June 14, 2021

## **Addendum No. 1:**

### **Project: PSFA PROJECT NO: P19-009 – Mesa Middle School Renovations and Addition – Roswell Independent School District and PSFA**

**D1 PHASING PLAN - PHASE 4 DEMOLITION**  
NTS

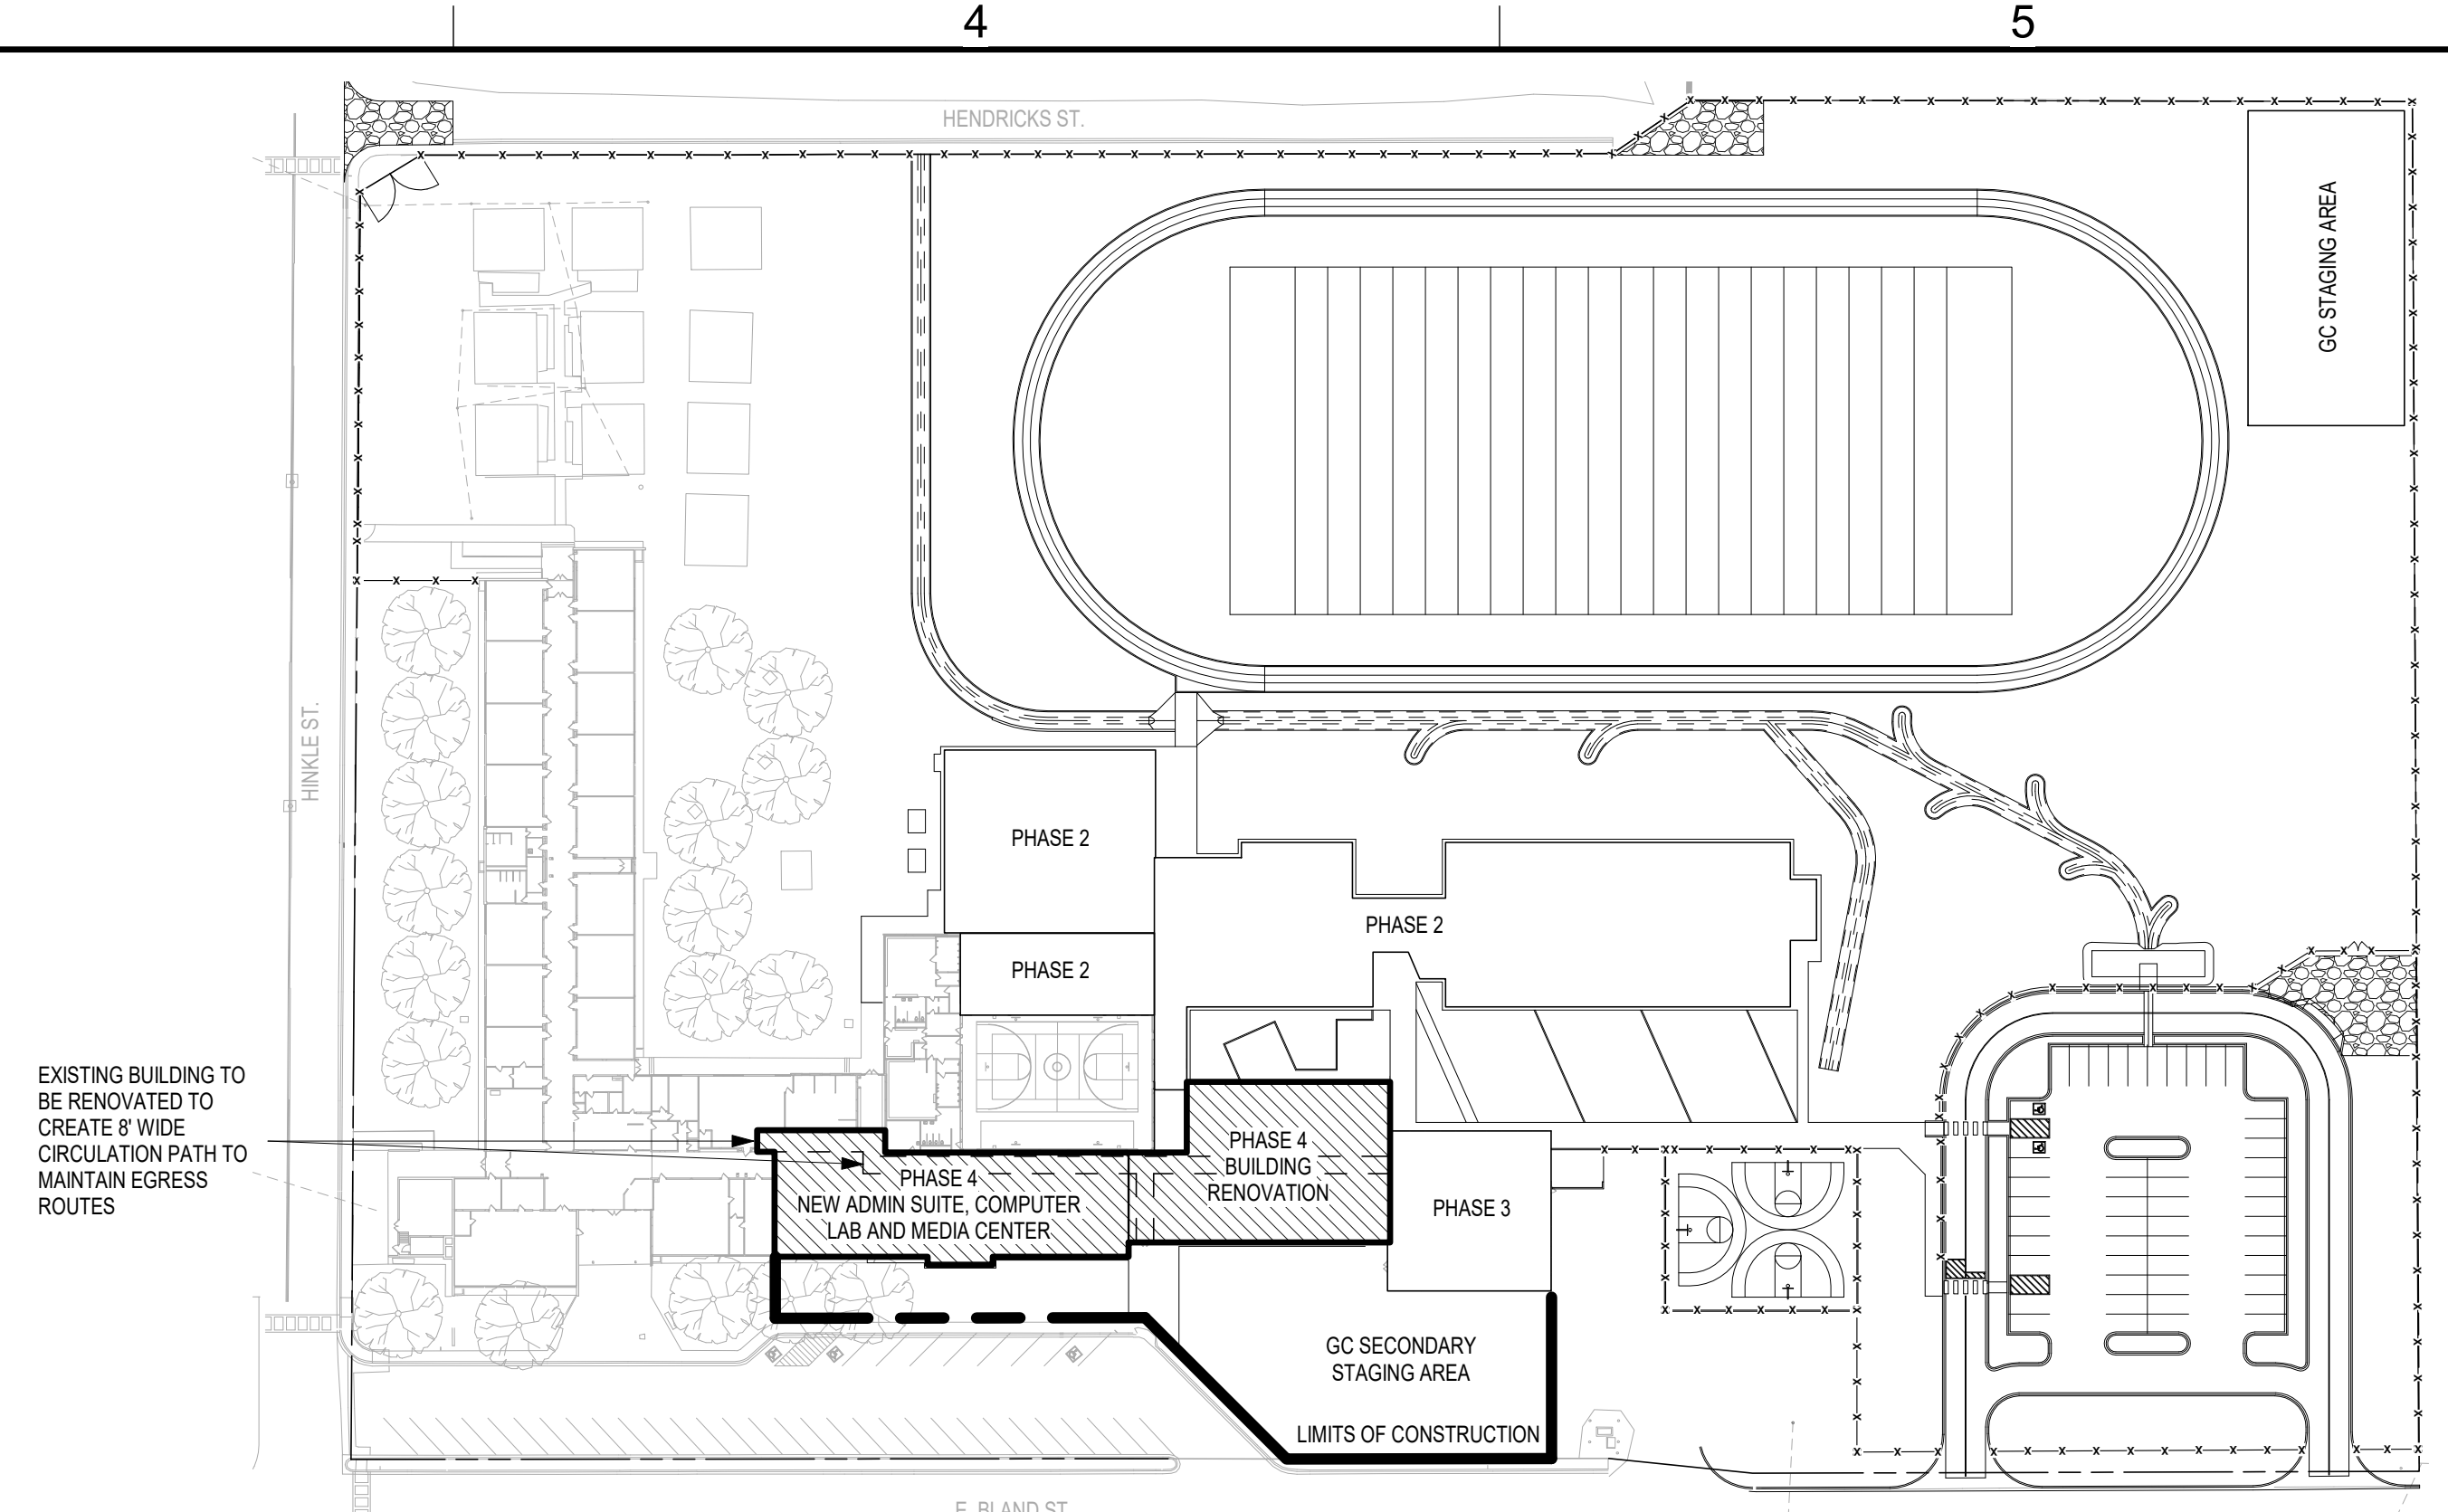
10. *G-005 specifies "Existing Cafeteria to be renovated during summer." Keeping in mind the anticipated award date of July 14, what is the deadline for completion of this portion of work?*

17. *Phasing Plan B2 "Phase 2 Demolition" indicates "corridor to remain accessible to students." Will this corridor need to remain open throughout construction?*
  - a. **Yes, path to cafeteria to remain open during construction.**
18. *How long will it take to relocate the school program to portables before Phase 2A commences?*
  - a. **No Phase 2A shown on Sheet G-005. Clarify question.**

- a. **See updated G-005 and G-005A Phasing Plans in this Addendum.**
11. *Is the General Contractor responsible for the abatement of existing facilities?*

**DEMOLITION ROOF PLAN AND ELEVATIONS**

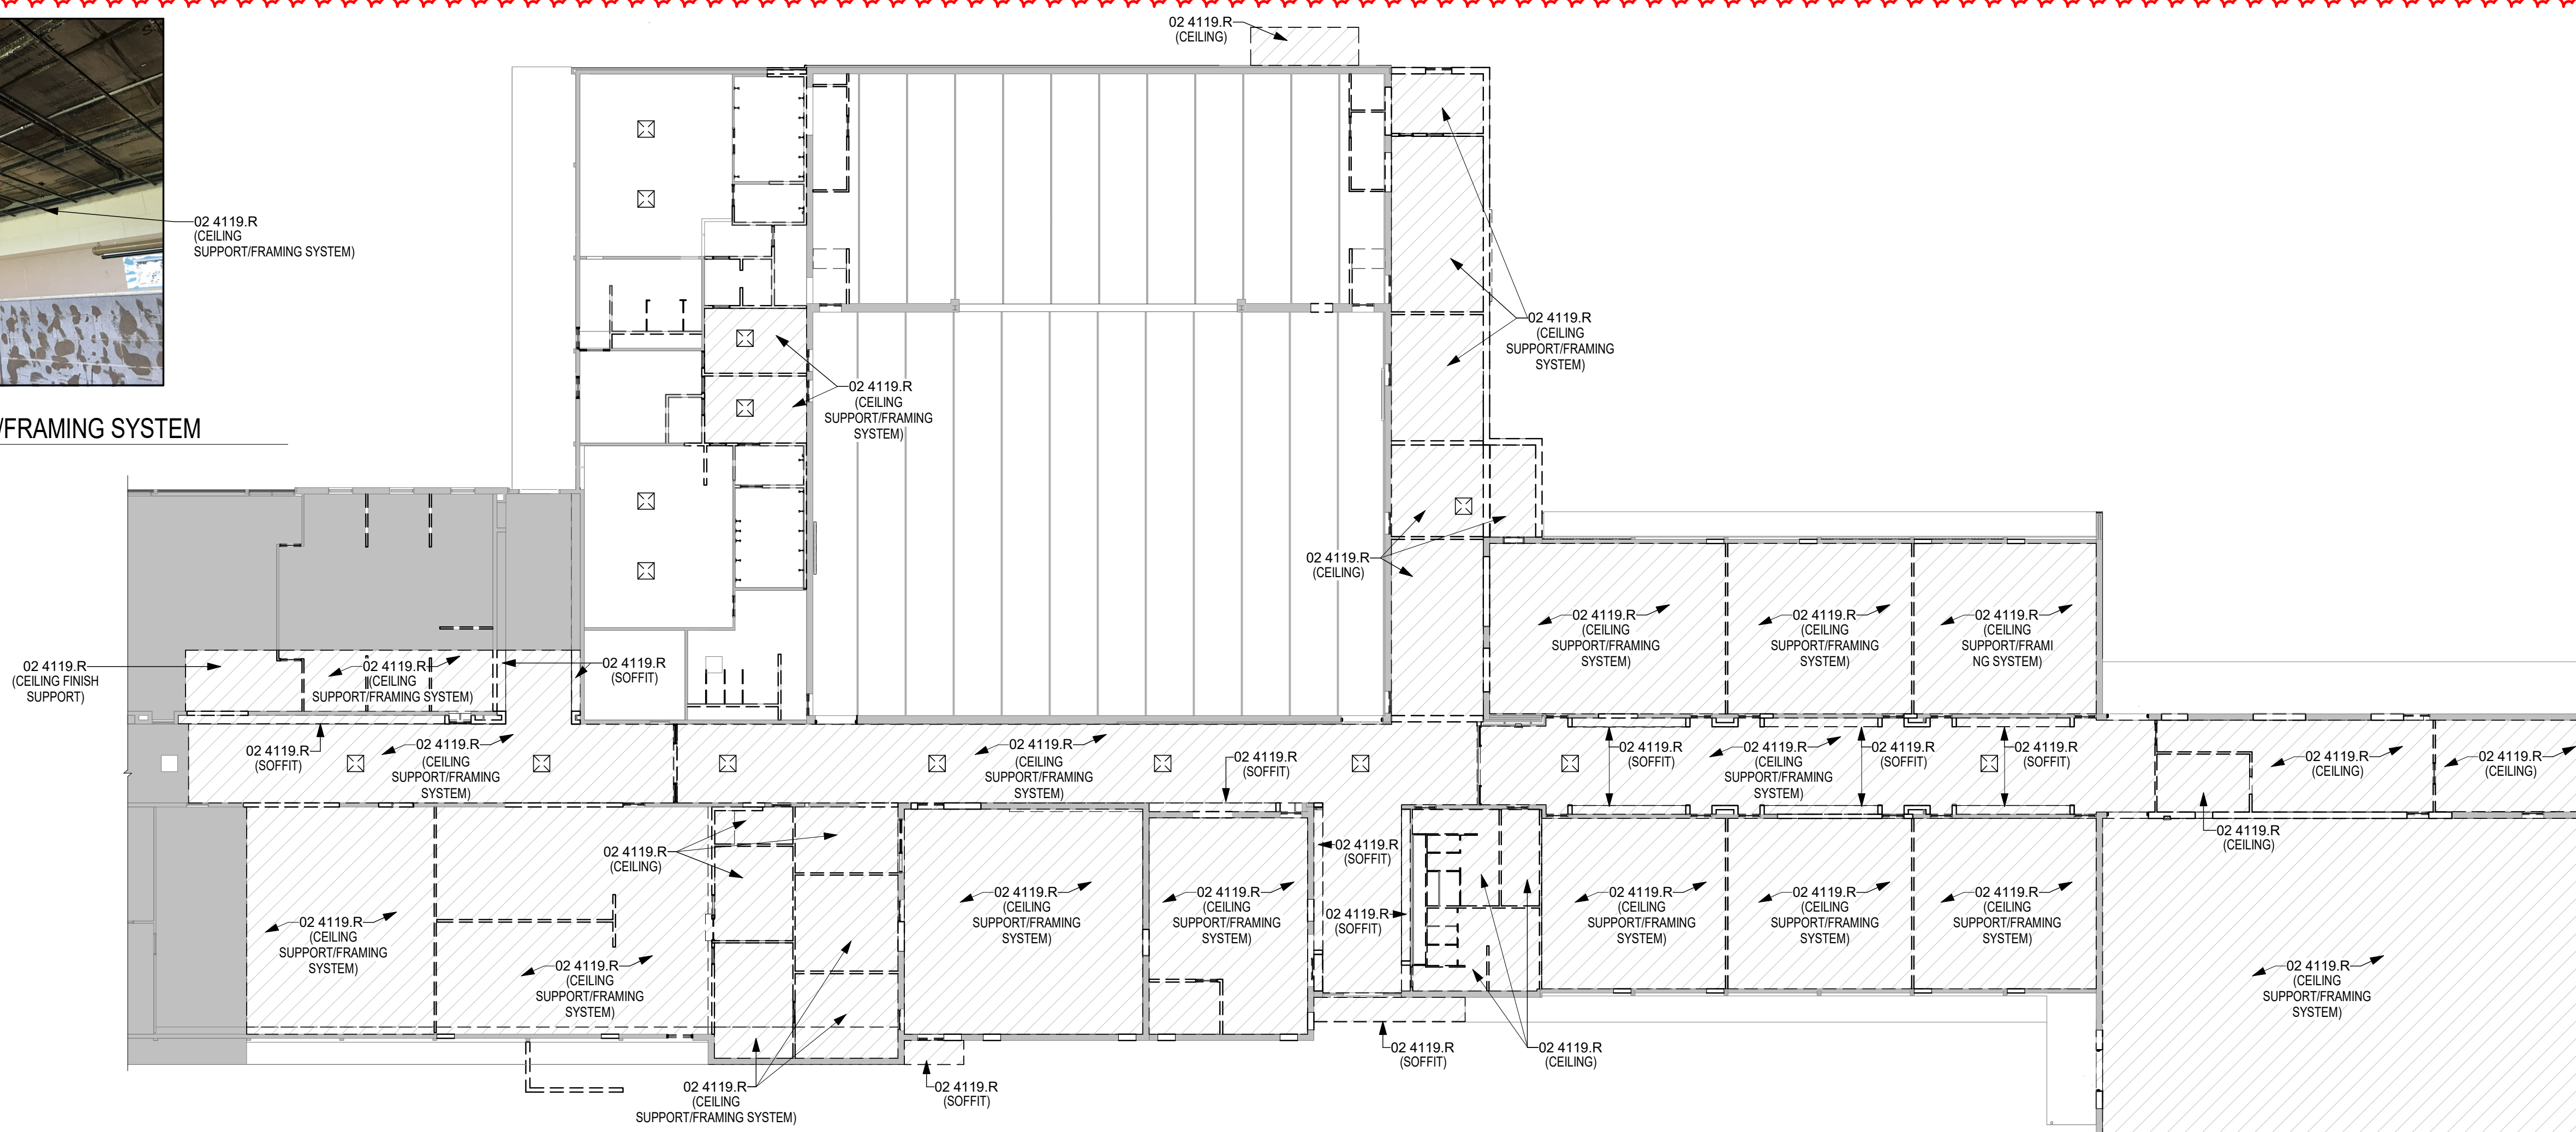
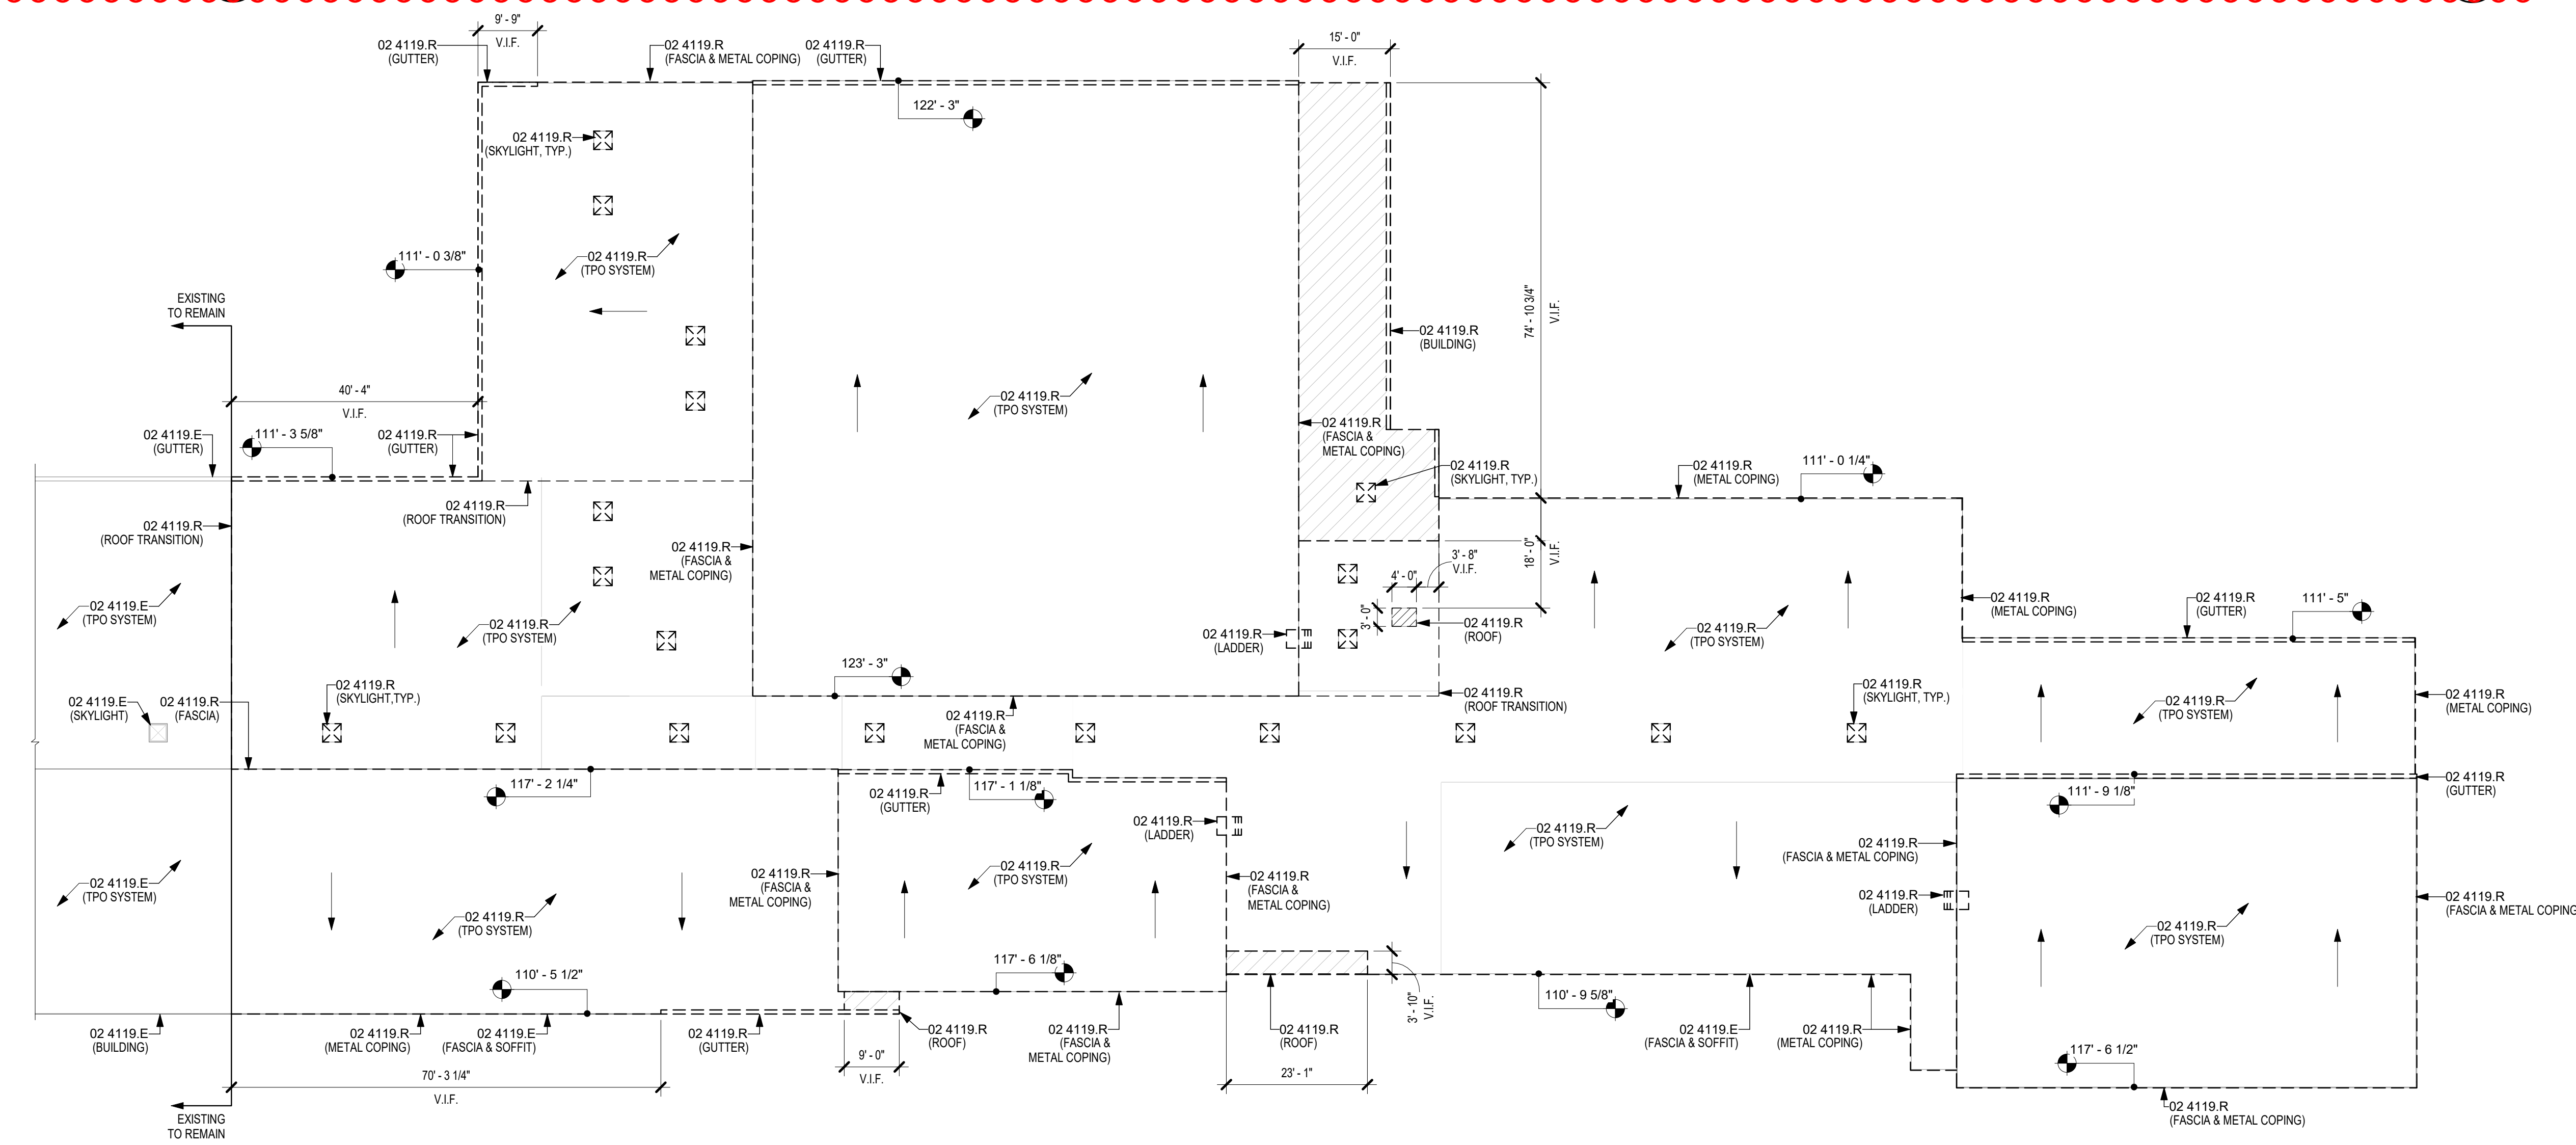
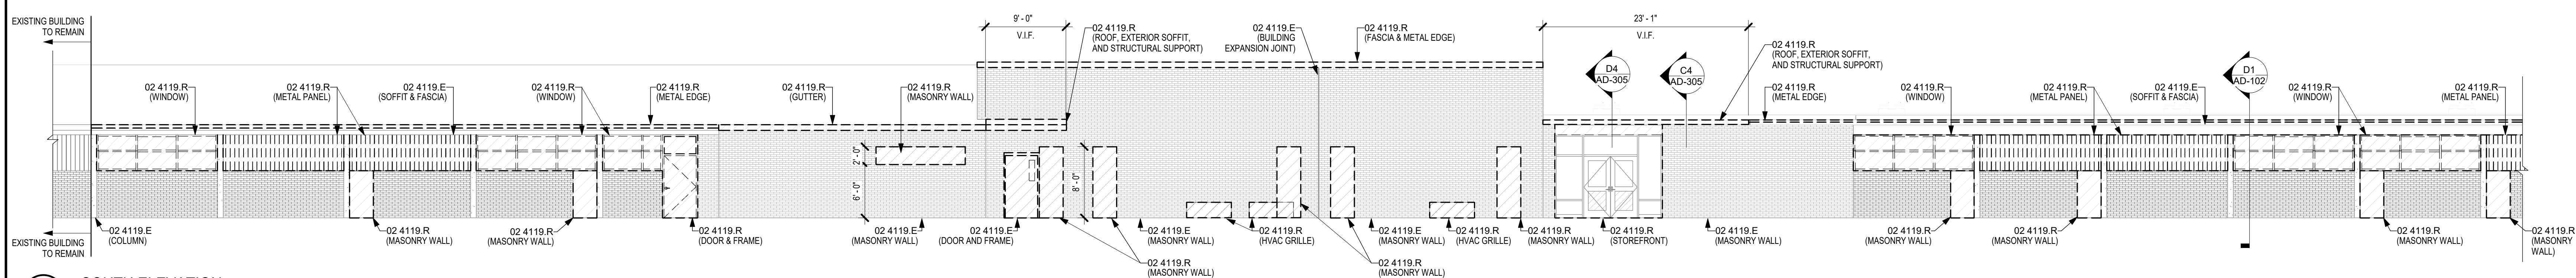
14. *The architectural demolition drawings indicate ceiling demolition NIC. Who will be doing this work?*
  - a. **See Attachment AD-105 DEMOLITION ROOF PLAN AND ELEVATIONS for clarifications.**

5. SHEET AD-102, AD-103, & AD-104:
  - A. **MODIFICATION:** Change General Note “B” to “REFER TO SHEET AD-105 FOR ADDITIONAL CEILING REMOVAL INFORMATION.”

- B. **ADD** General Note “K. ACM REMOVAL BY OWNER. GC TO REMOVE REMAINING CEILING SUPPORT/FRAMING SYSTEM TO FACILITATE INSTALLATION OF NEW WORK.”
6. SHEET AD-301, AD-302, AD-303, AD-304, AD-305, AD-901, AD-902, AD-903, & AD-904:

- A. **MODIFICATION:** Change General Note “B” to “REFER TO SHEET AD-105 FOR ADDITIONAL CEILING REMOVAL INFORMATION.”
  - B. **MODIFICATION:** Change General note “K. to “ACM REMOVAL BY OWNER. GC TO REMOVE REMAINING CEILING SUPPORT/FRAMING SYSTEM TO FACILITATE INSTALLATION OF NEW WORK.”
